Model: Adonis-C3 ARDF (DF76)	Date: 8-Jan-04	No.: MB541001
------------------------------	----------------	---------------

Modified Article: Parts catalog correction		Prepared by: Y.Urushihara	
From: 1st Tech. Support Sec. Service Support Dept.			
Reason for Modification:	☒ Parts catalog correction	☐ Vendor change	☐ To meet standards ()
	☐ To facilitate assembly	☐ To improve reliability	
	☐ Part standardization	☐ Other

Model: Adonis-C3 ARDF (DF76)		Date: 16-Sep-04	No.: MB541002
Modified Article: Pressure Plate Assy		Prepared by: K. Takagi	
From: 1st Tech. Support Sec. Service Support Dept.			
Reason for Modification:	☐ Parts catalog correction ☐ To facilitate assembly ☒ Part standardization	☐ Vendor change ☐ To improve reliability ☐ Other	☐ To meet standards ()

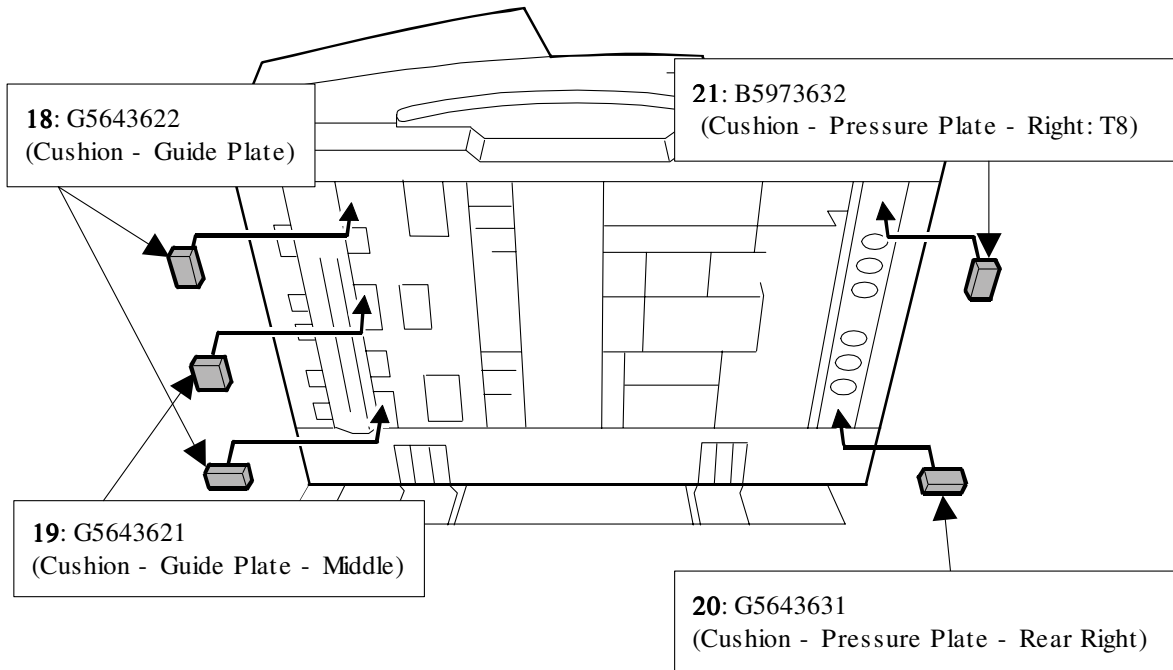
Old part number	New part number	Description	Q'ty	Int	Page	Index	Note
B3514351	B5974311	Pressure Plate Assy	1	X/O	21	10	
B3514333	-	Cushion - Pressure Plate	2-0		21	15	
B3514322	B3514322	Tape - Platen Sheet	4-1		21	9	
	B5974326	Cushion Tape - Left	2		21	16	
	B5974333	Cushion Tape - Middle	2		21	17	
	G5643622	Cushion - Guide Plate	2		21	18	
	G5643621	Cushion - Guide Plate - Middle	1		21	19	
	G5643631	Cushion - Pressure Plate - Rear Right	1		21	20	
	B5973632	Cushion - Pressure Plate - Right: T8	1		21	21

Reason: Parts standardization with the Model - JC1 ARDF (DF77).

Important: See the next page for important notes on installing the new parts.

Installing the Velcro Patches (“Cushion” and “Cushion Tape”)

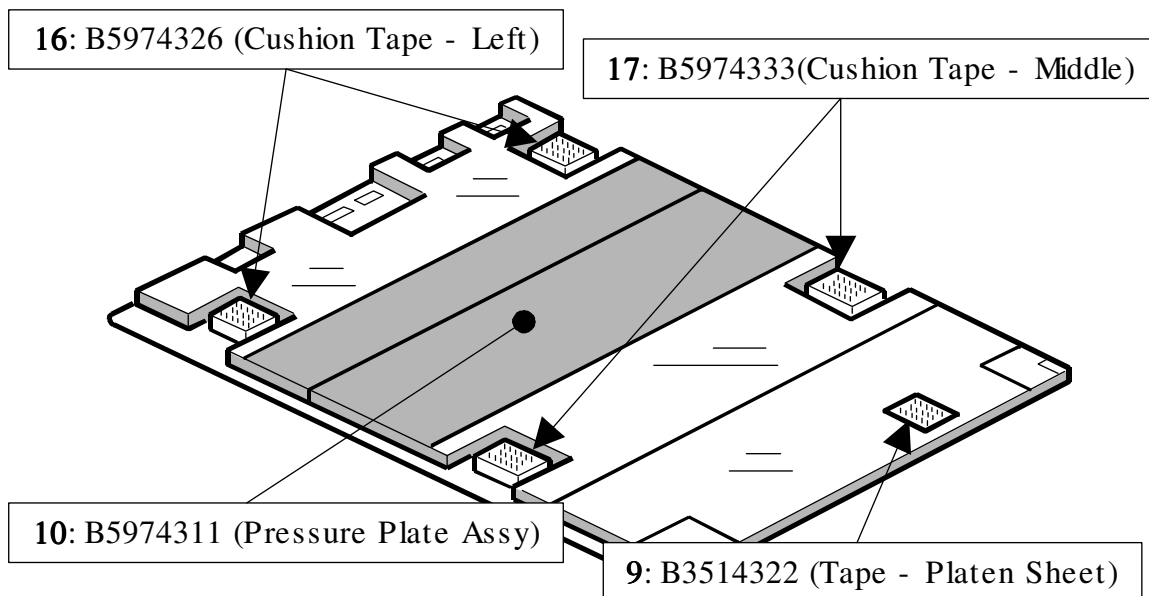
1. Remove the Pressure Plate.
2. Remove the 5 old Velcro patches from the underside of the ADF.
3. Attach the new Velcro patches to the underside of the ADF (#18-21 below).

4. Attach the new Velcro patches to the underside of the Pressure Plate (#9, 10, 16, 17 below):
